# Answers to the questions from the review committee

DUNE TPC Electronics ASIC Team

22 July 2021

# VDDA2P5 power supply net (Avg)

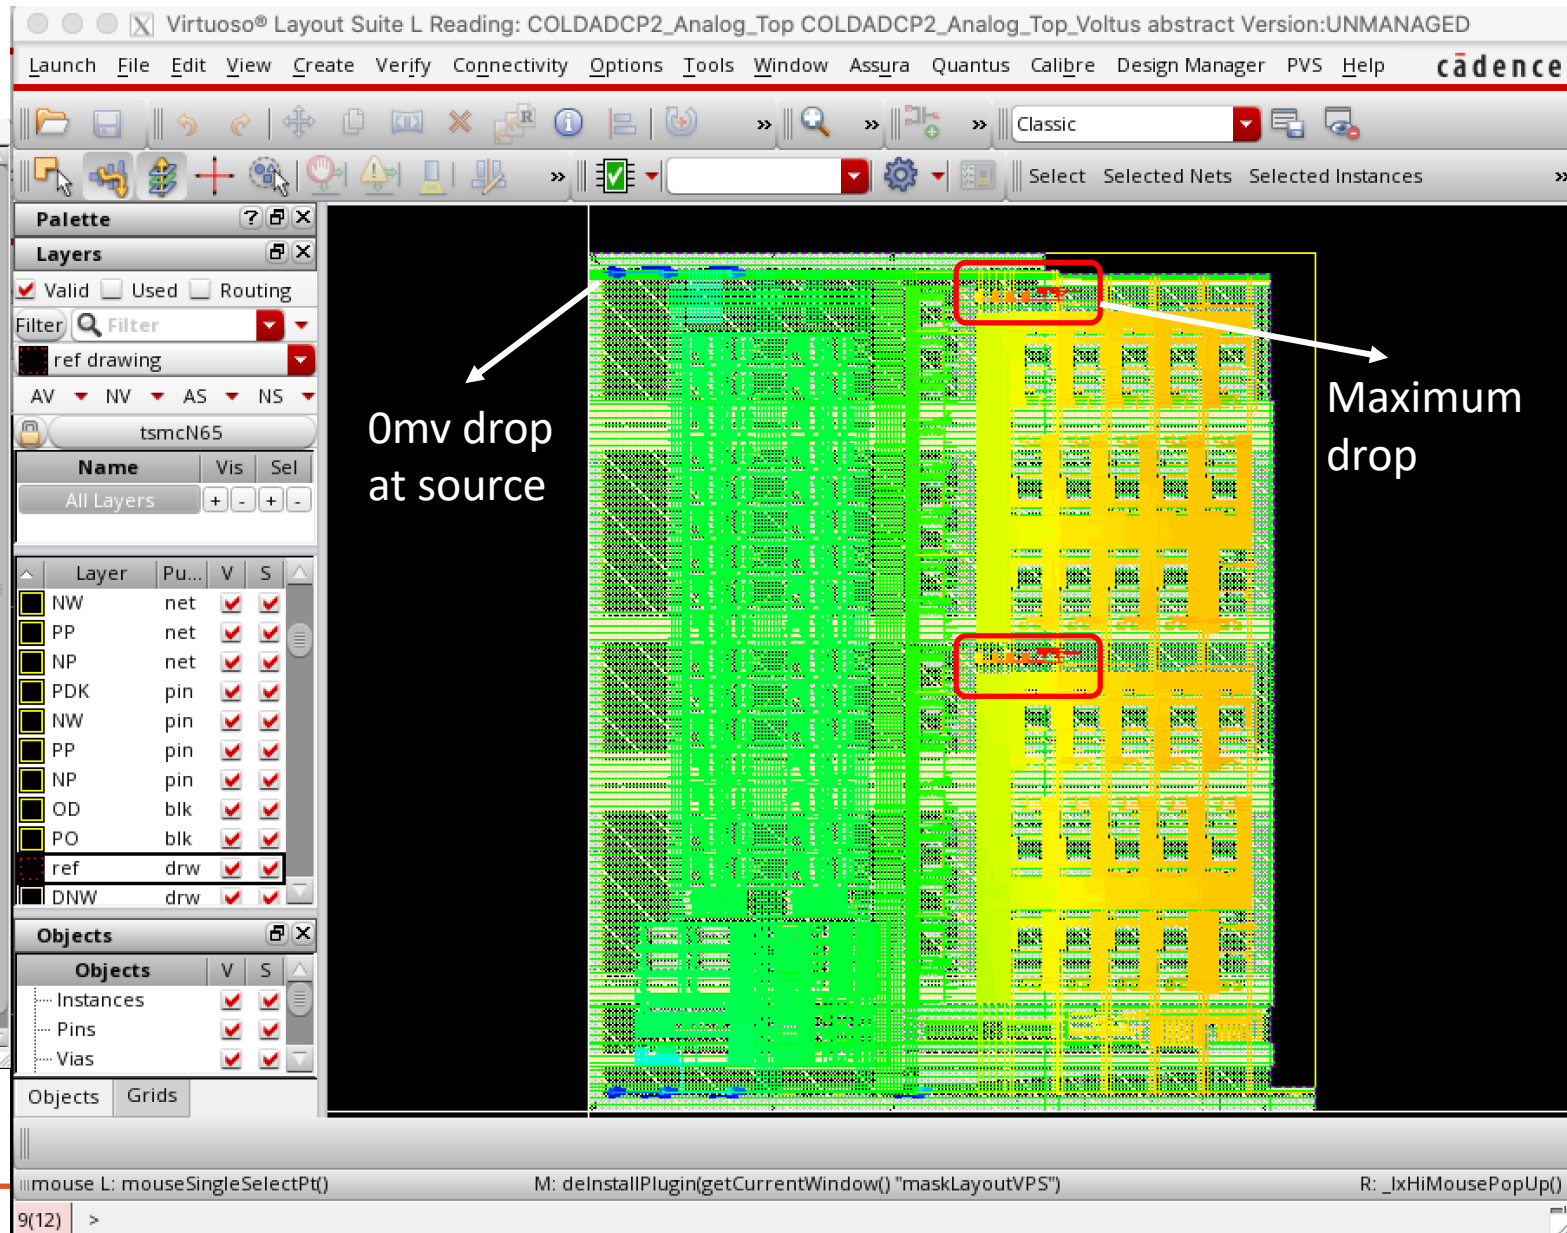
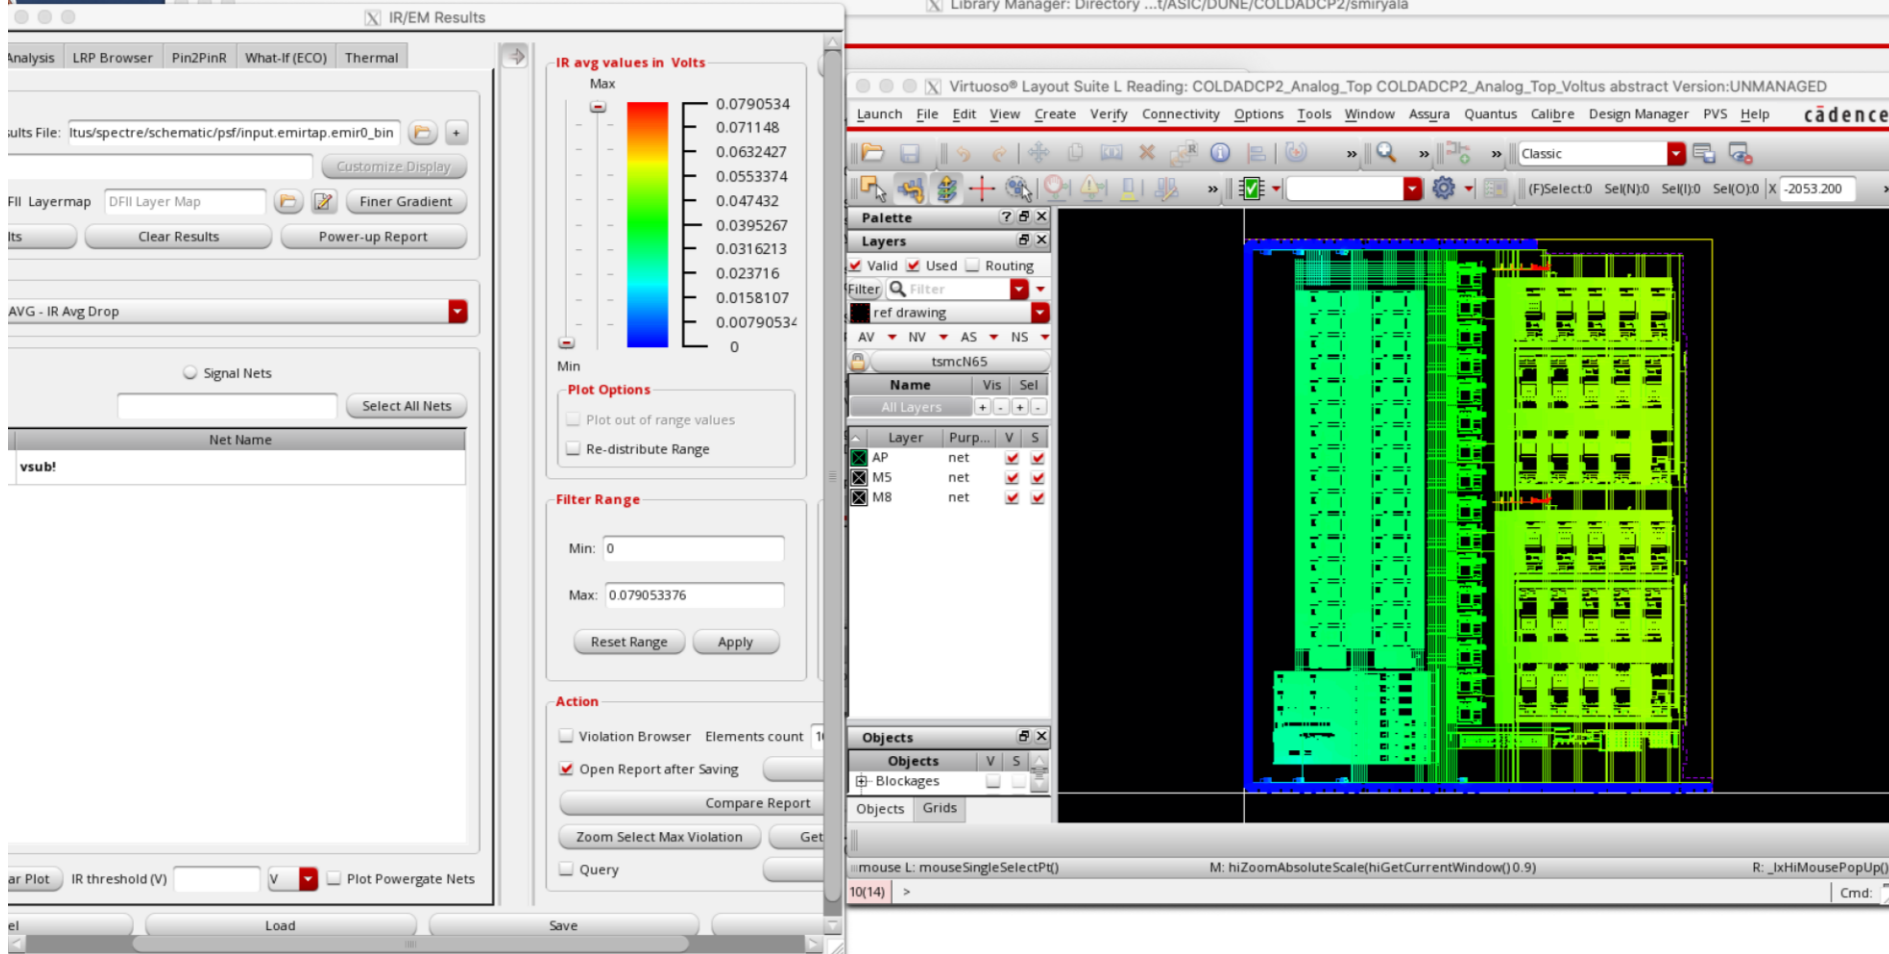
- The following points for COLDADC and COLDDATA should be clarified:
  - Is there an estimation of the coverage that was achieved in simulation.
- Jim Hoff (Fermilab),
  - What is the IR drop that they have on the chip. In case it is marginal, it could affect the yield. TSMC specify that the static IR-drop in should be  $< 3\%$  of VDD, and the dynamic  $< 15\%$  of VDD. If it is a bit higher but controlled, it can be ok but it would be good to know.
- Sandeep Miryala (BNL) (only for ColdADC, we did not run IR drop analysis for COLDDATA because there we did not observe any problem related to IR drop in first full prototype COLDDATA p2)

**80 mV on VDDA2P5 + 80 mV on Vsub! = ~160 mV**

**% IR drop =  $\sim 160\text{mV} / 2.25\text{V} = \sim 7\%$**

# Jitter specification

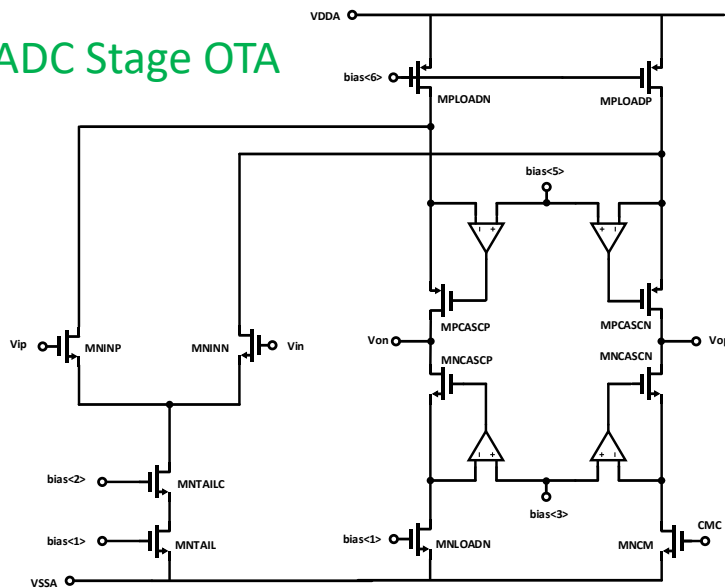
- For the ADC specification and QA/QC, the documentation is good, but it may be useful to the team to add specs for clock jitter, supply voltage PSRR, calibration stability, acceptable calibration values, time needed to calibrate (it was said it is fast, but what is fast), eye opening. This could be used to refine QC plan, i.e. put thresholds on some parameters to accept/reject chips.

$SNR \text{ (dBFS)} < -20\log(2\pi f_{in}\sigma)$ , where  $f_{in}$  is the maximum input frequency and  $\sigma$  is the rms clock jitter.

For a 12-bit ADC, the ideal SNDR is about 72 dB and  $\max f_{in} = 410 \text{ kHz}$  (LArASIC BW with  $0.5 \mu\text{s}$  shaping time)

Solving for  $\sigma$  we have **rms jitter must be  $< 97.5 \text{ ps}$**

Shaping Time [ $\mu\text{s}$ ]	Bandwidth [kHz]	Jitter spec [ps-rms]
0.5	410	97.5
1	216	185
2	110	363
3	73	548

- Summary of Simulation Level
  - Document: *ColdADC – Expected Performance from Simulation*

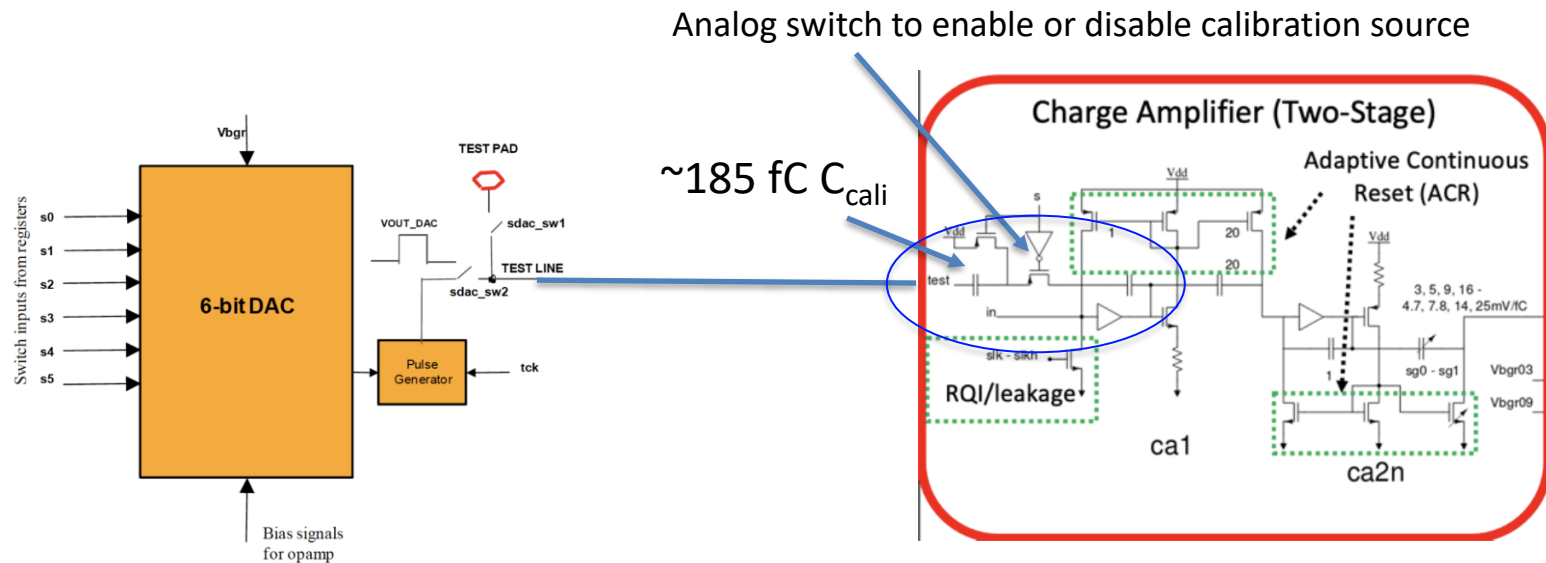
- The simulation documentation shows very nice expected performance. What is the level of these simulation (schematic/layout? extracted R+C+CC)? Are the results in Fig. 12 of the document on simulation of the ColdADC, for example, a full chip, transistor-level simulation? Is the input network simulated? Are there plans for additional simulation after submission?

Most of the simulations showing circuit performance were done with extracted R+C+CC layout. Several of the “system level” simulations were made using an analytical model of the ADC and calibration algorithm in MATLAB

The input network was included (a simple model representing LArASIC’s output impedance) for the SHA simulations.

The simulation level for the various figures in the Simulation Document are captured on the next slide. There are no plans for further simulation.

Figure(s)	Simulation Level	Comments
3	R+C+CC	SHA Functional Sim
4	Schematic	SHA switch on-resistance
5	R+C+CC	SHA Linearity
7	RTL	Clock phase generation
8	Schematic + Verilog-AMS	Bottom plot Verilog-AMS model
10	Schematic	ADC functionality
11	Schematic + RTL	Calibration functionality
12 & 13	MATLAB model	Expected performance (analytical)
16,17,20,23 -25,29	R+C+CC	Block simulations
26 & 28	Schematic	Block Simulations

- Uniformity of response along channels

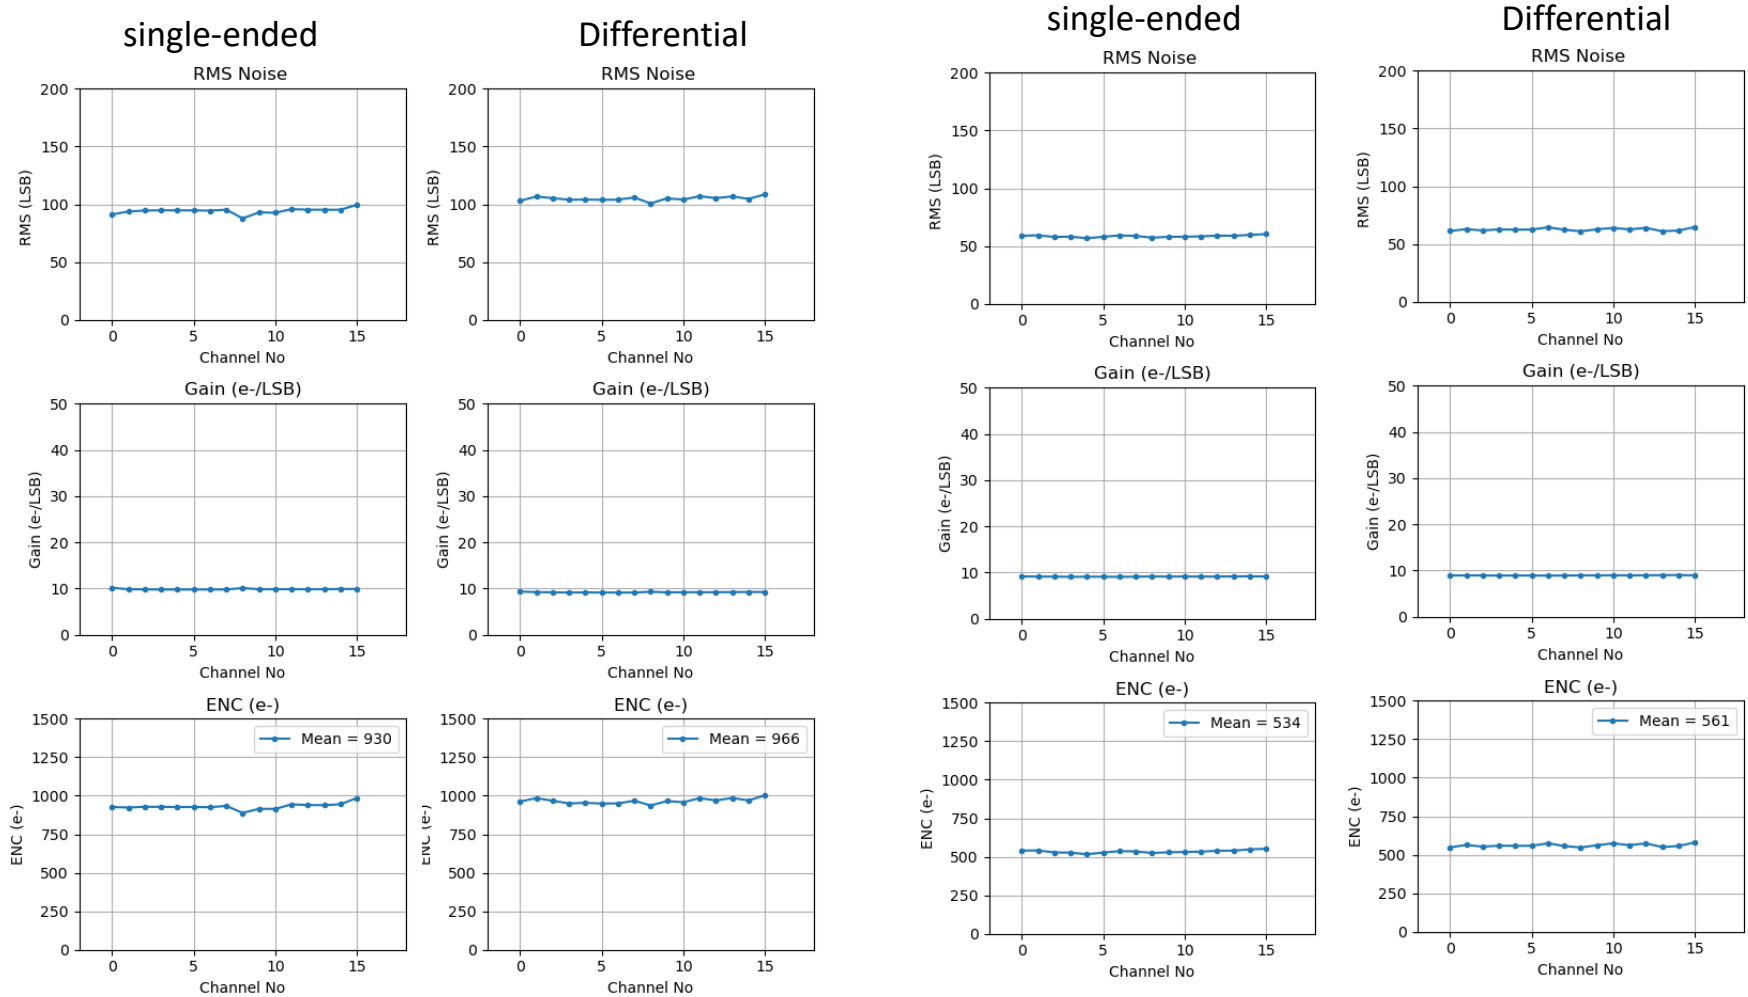
- Concerning the tests done with the new prototype FEMB, were there injections on each channels ? Do you have a plot showing uniformity of response along channels

- A full chain test done with test card with LArASIC p5 and ColdADC p2 (measurement in progress with FEMB)
